Drainage Management in South Jandakot and for the Beeliar Wetlands

Report to the Environmental Protection Authority
by
A Technical Advisory Group

Environmental Protection Authority
Perth, Western Australia
Bulletin 371 March 1989

Figure 5. Hydrographs

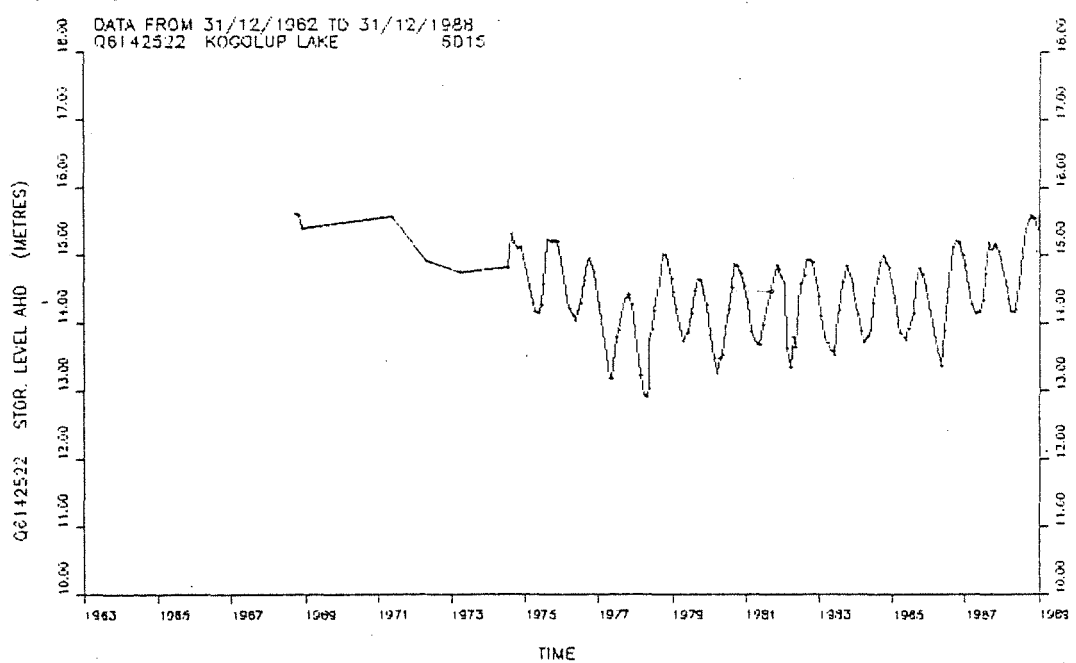
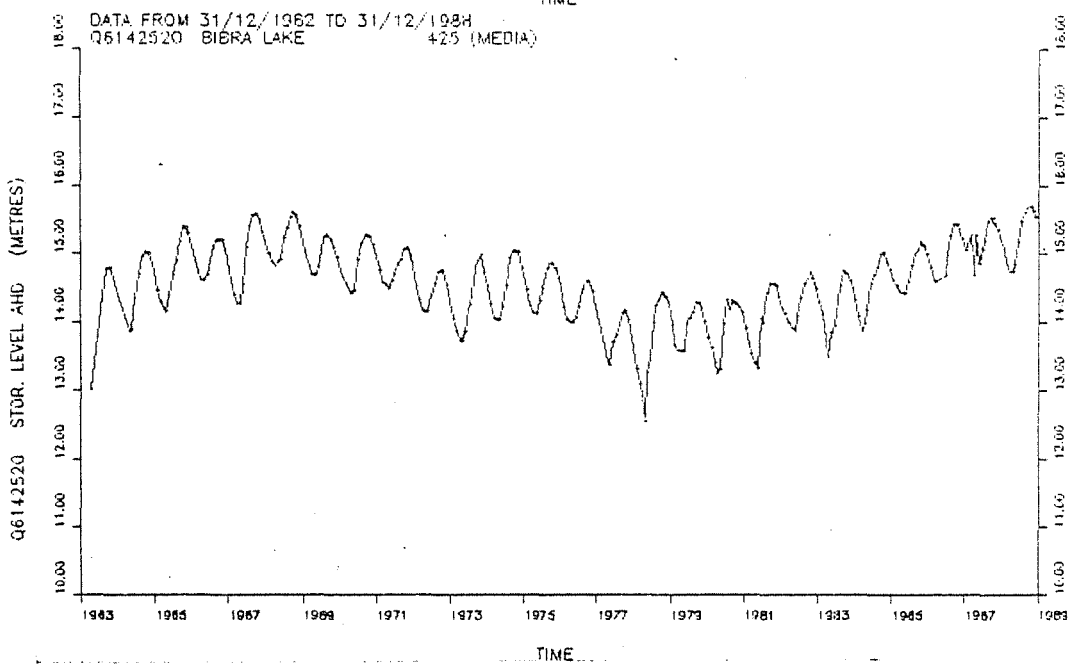
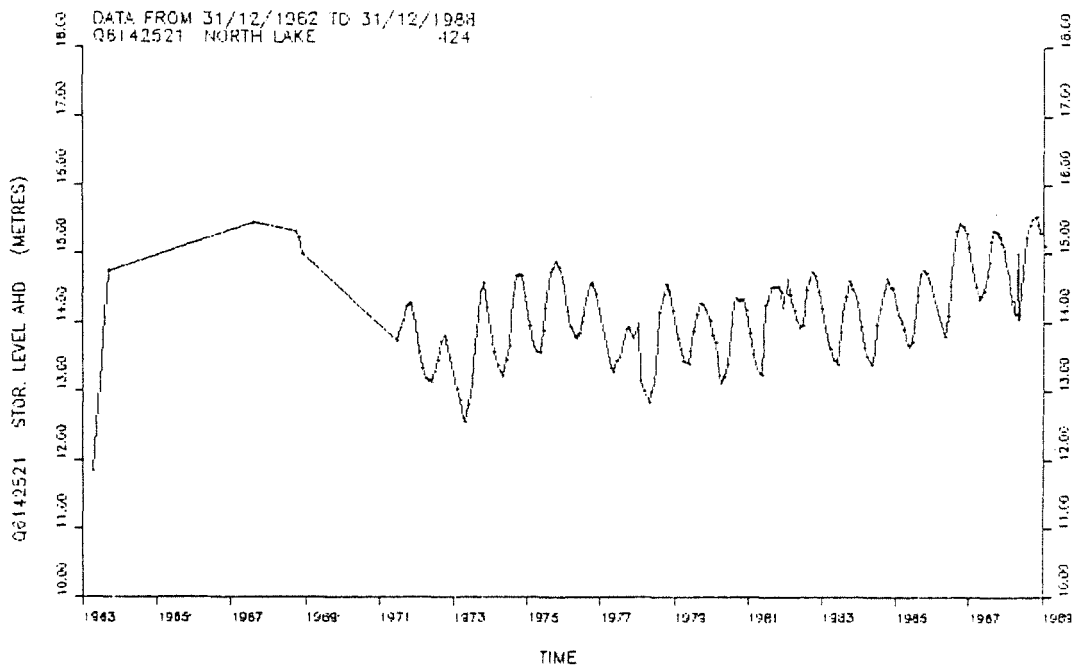
The hydrographs of Kogolup Lake and Thomsons Lake indicate that the water level of Kogolup Lake has risen approximately 0.7 metres in the last 10 years (1978-1987) despite low rainfall (Figure 5). This could be due to the effects of very high water levels in Yangebup Lake or other effects of urbanisation. Pumping out facilities should be provided, as well as the ability to allow water of suitable quality to enter Kogolup Lake.

Figure 7. Drainage Catchment Boundaries.

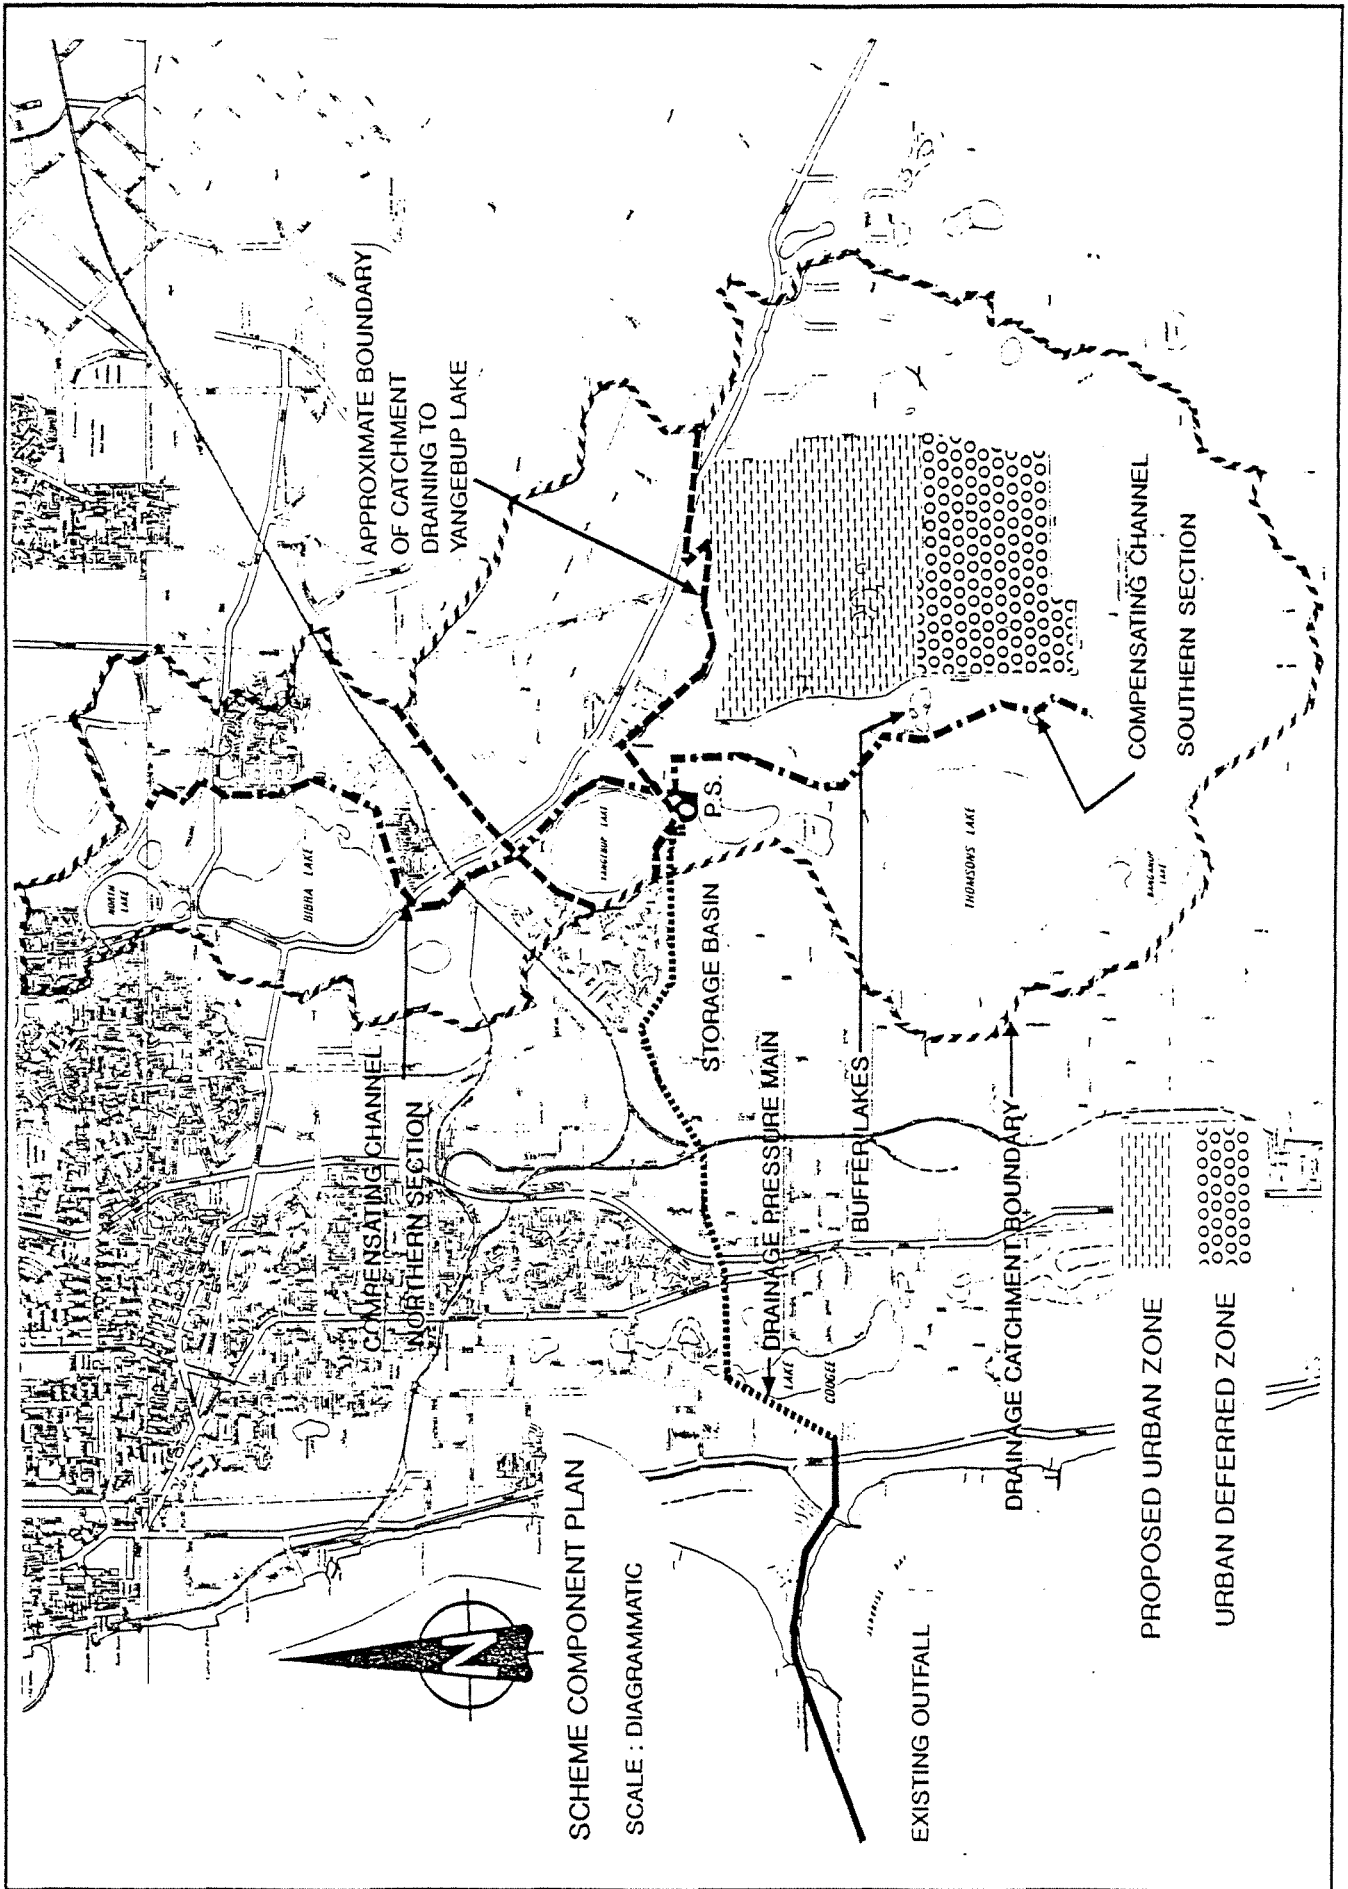
The drainage catchments which naturally discharge into lakes in the Beeliam Park are shown in Figure 7 while Figure 2 shows the layout of the proposed drainage system along with the key components and their functions. Some peak flow rates are also quoted.

The TAG feels that these principles are acceptable except for number 13 and that environmental protection or water quality standards are not specifically addressed.

Figure 8. Depth to Water Table Contours

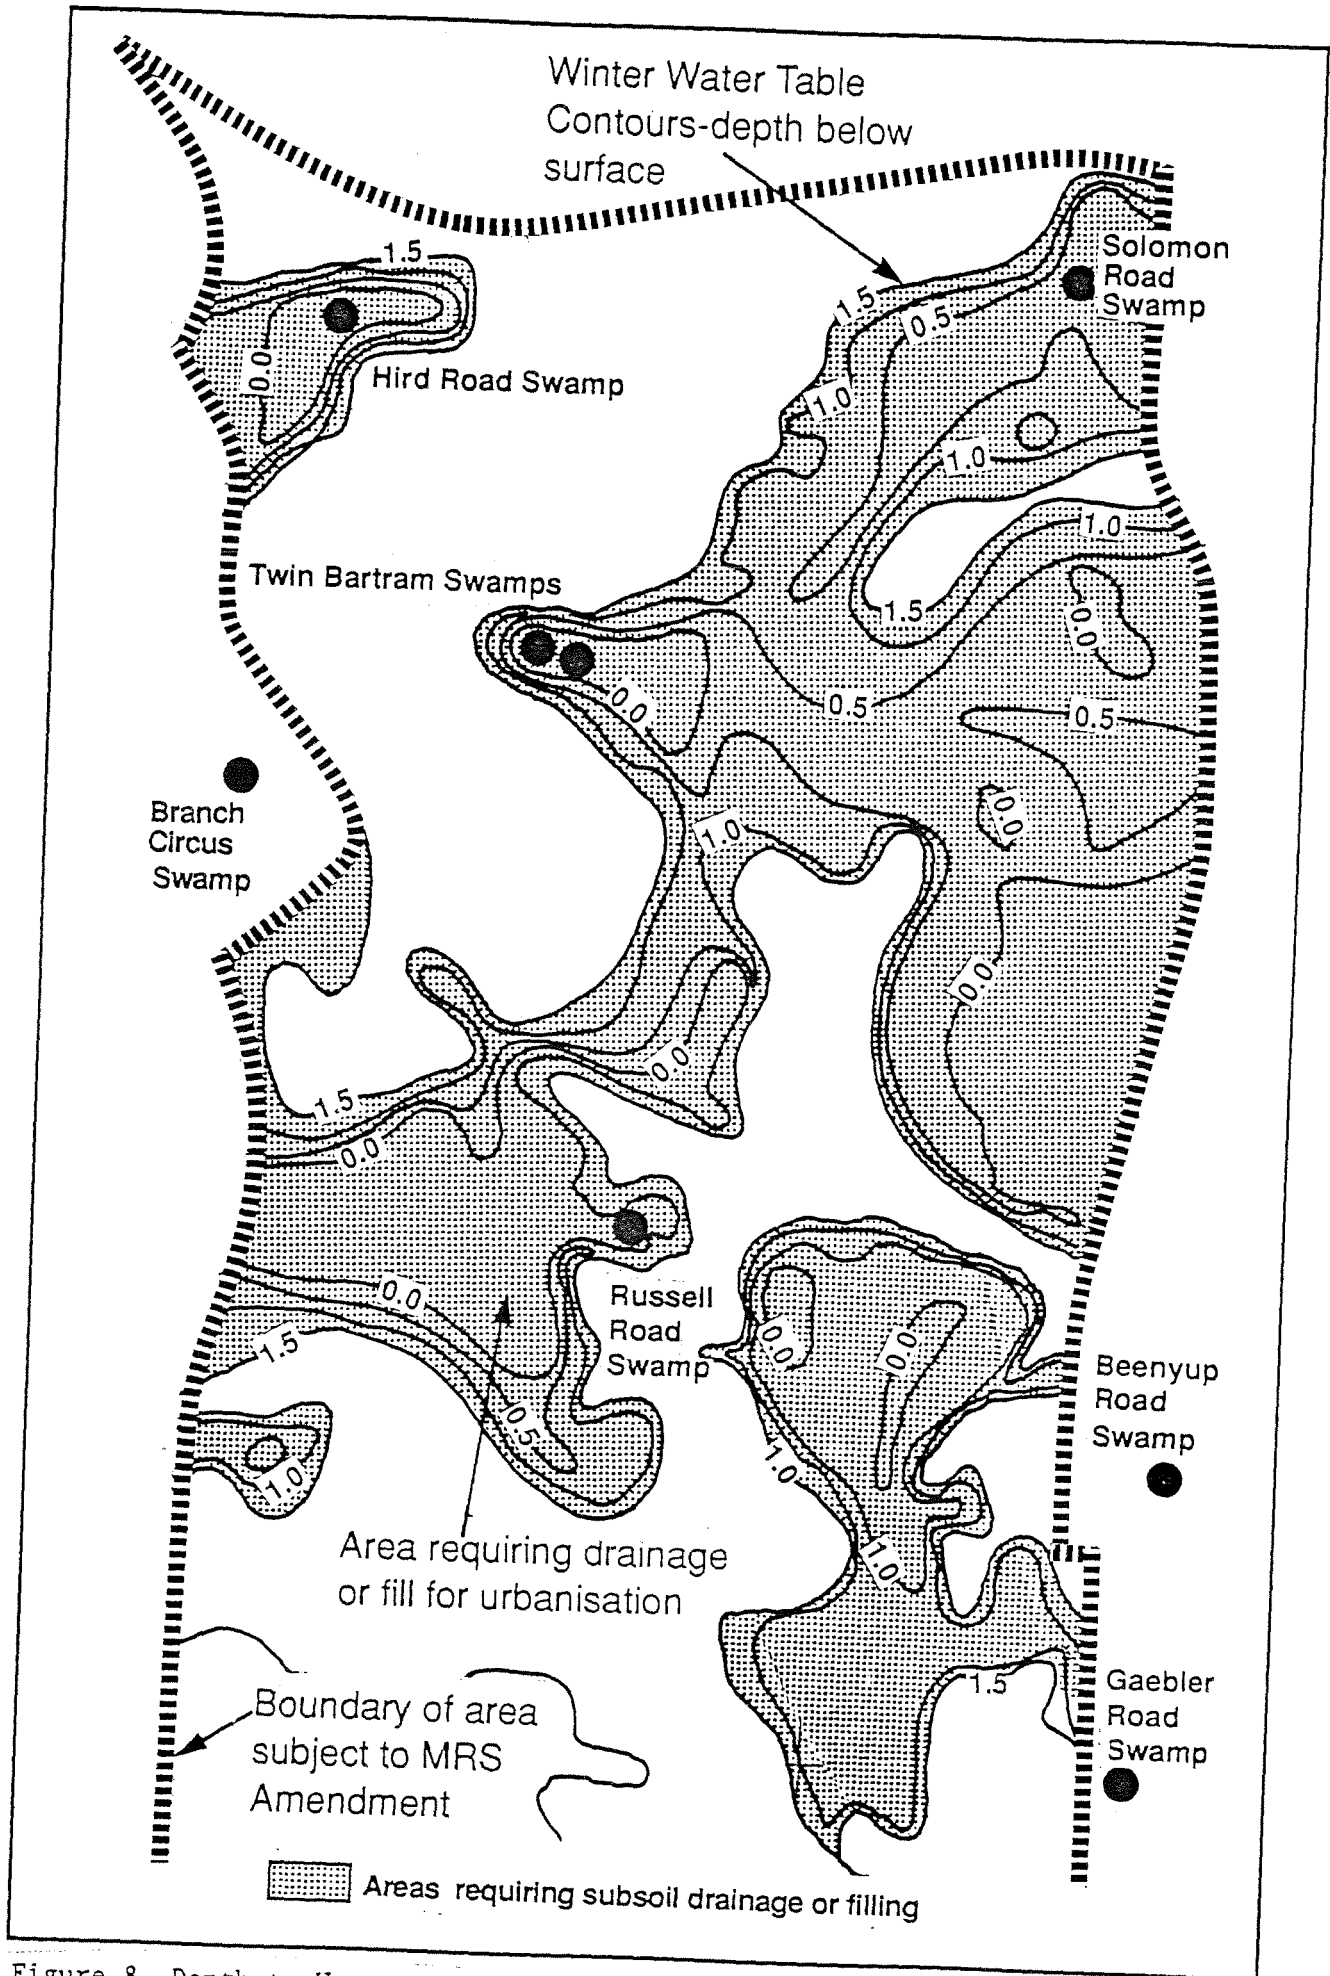
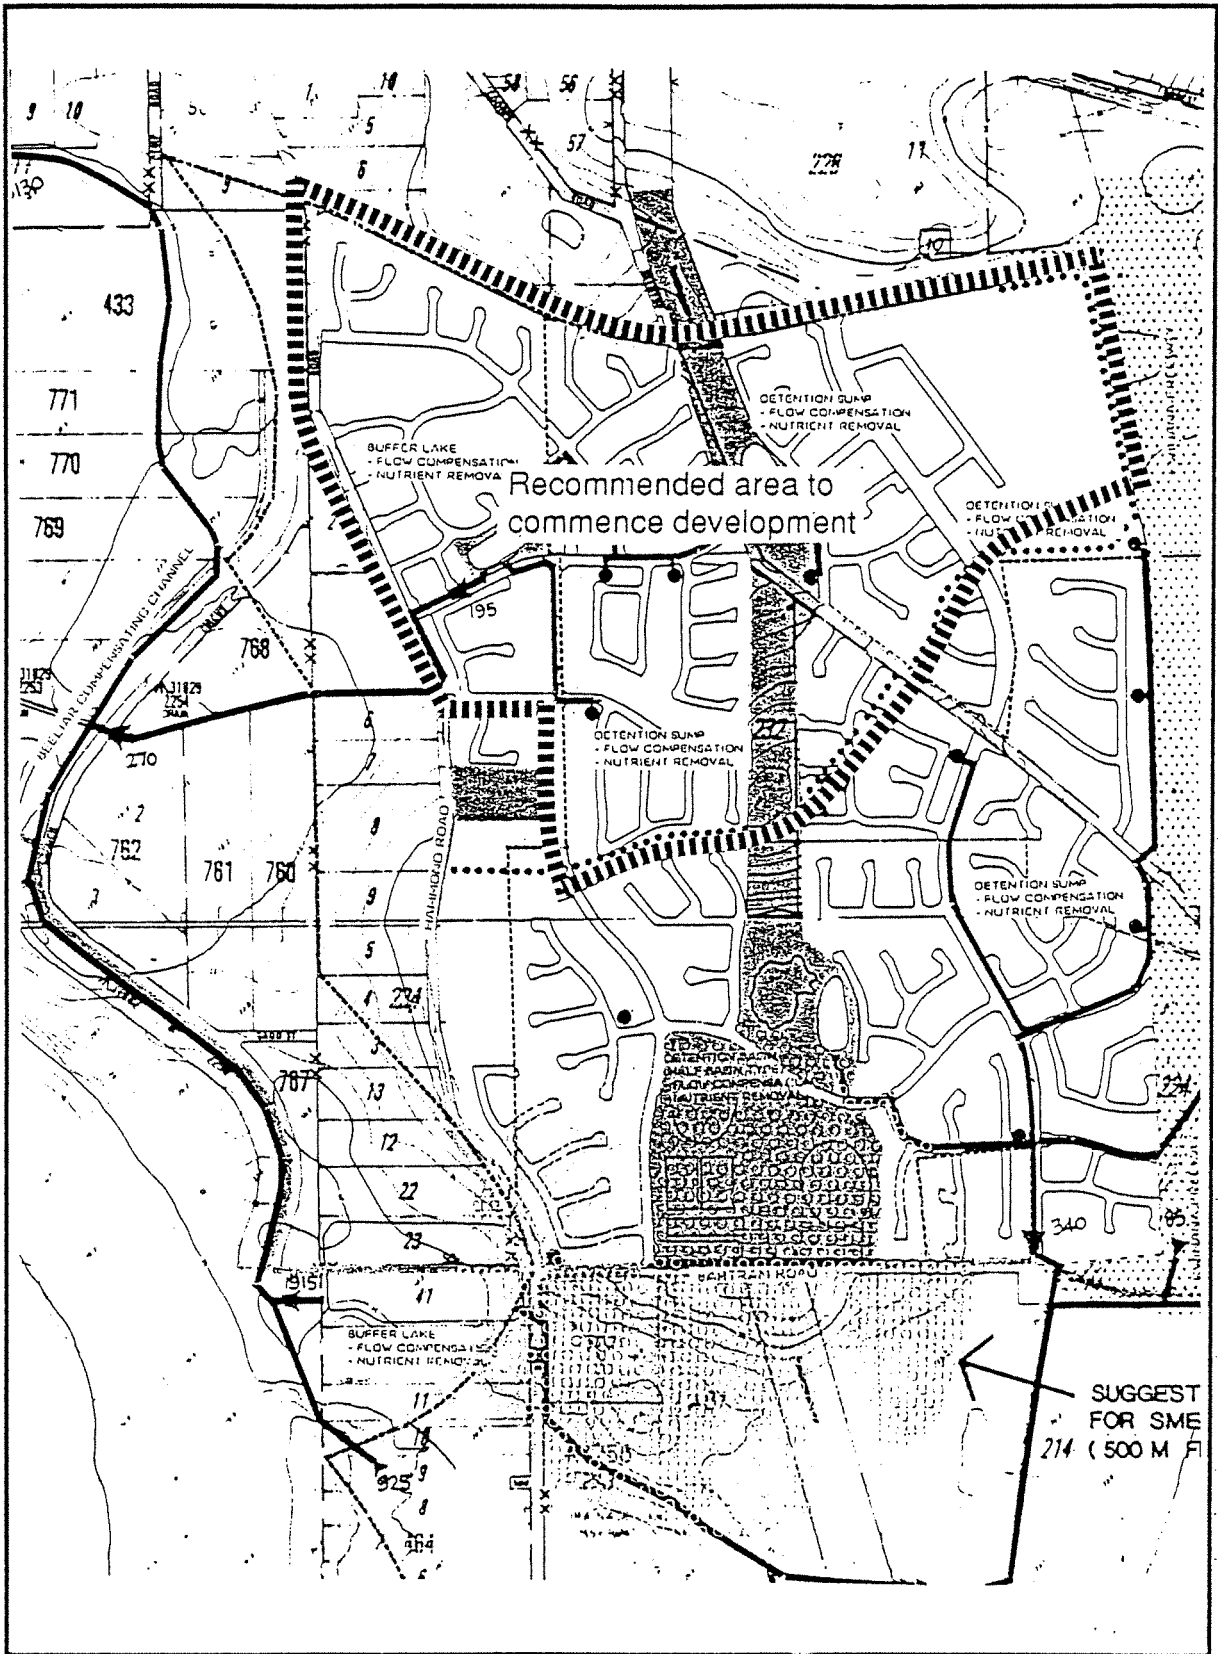
- . it should proceed on a catchment by catchment basis commencing with the area of high depth-to-water-table based on the Hird Road wetland catchment as illustrated in Figures 8 and 9.
- . the best design principles for groundwater protection should be incorporated (see Appendix 3);
- . the developer in consultation with the EPA and the SPC install facilities to prevent, treat, remove or otherwise contain nutrients within the urban area;

- . the sale of lots should not proceed until a drainage mechanism from the estate Lake is in place and until a pump station has been installed to remove excess water; and
- . the development and drainage from it should be monitored and that extension of the urban-rezoning be conditional on successfully demonstrating that criteria with respect to drainage can be achieved on an ongoing basis.
